STAFF REPORT
KETCHUM PLANNING AND ZONING COMMISSION
REGULAR MEETING OF SEPTEMBER 23, 2025

PROJECT: Sawtooth Serenade

FILE NUMBER: P24-027

APPLICATION: Final Design Review

1ST AVE ELEVATION

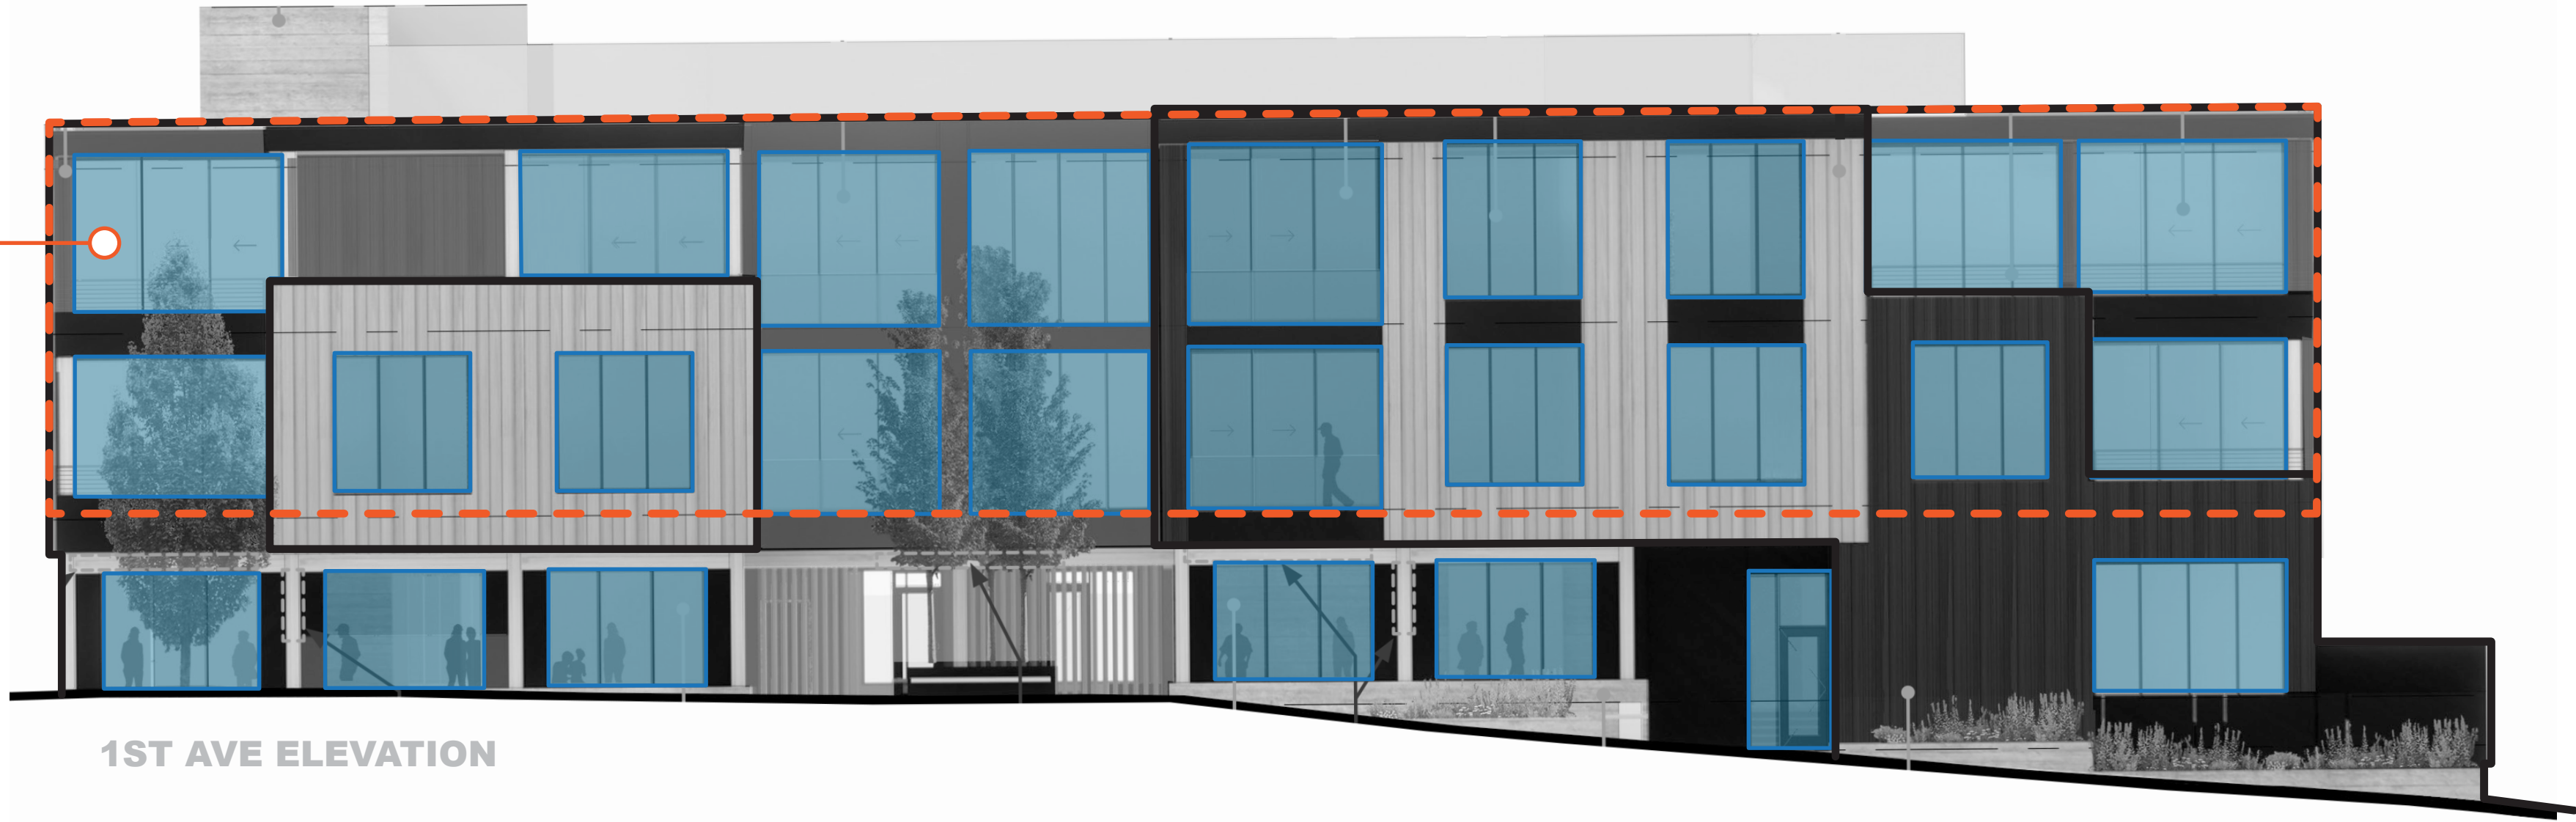
- The amount of glazing on the middle and upper levels along 1st Avenue has been identified in both the staff report and in Commission discussion as incompatible with the existing fabric of development. Commissioner Morrow stated, “I still think there is too much glazing on that side (1st Avenue upper two levels).” In response to these concerns, the area of glazing on the middle and upper levels of Sawtooth Serenade has been reduced by 12%. Areas of siding and stone veneer have replaced windows, increasing the amount of solid wall to 56% of the overall facade. Beyond simply reducing the amount of glazing, windows and doors have been further recessed or reconfigured to reduce their visibility from 1st Avenue and the surrounding area.

- By comparing Sawtooth Serenade’s glazing along 1st Avenue to other projects recently approved by the P&Z within two blocks of Sawtooth Serenade, it is clear that the proposed glazing is in keeping with the fabric of development in this area. To illustrate this point, sheet A0.13 has been added to this submittal set. The percentage of glazing on the upper levels of the Perry Building is 55%, Sawtooth Serenade is 46%, Maude’s is 45%, 1st and 4th is 44% and 1st & Sun Valley Road is 31%. The percentage of glazing facing 1st Avenue on the middle and upper levels of Sawtooth Serenade falls well within the range of the approved projects.
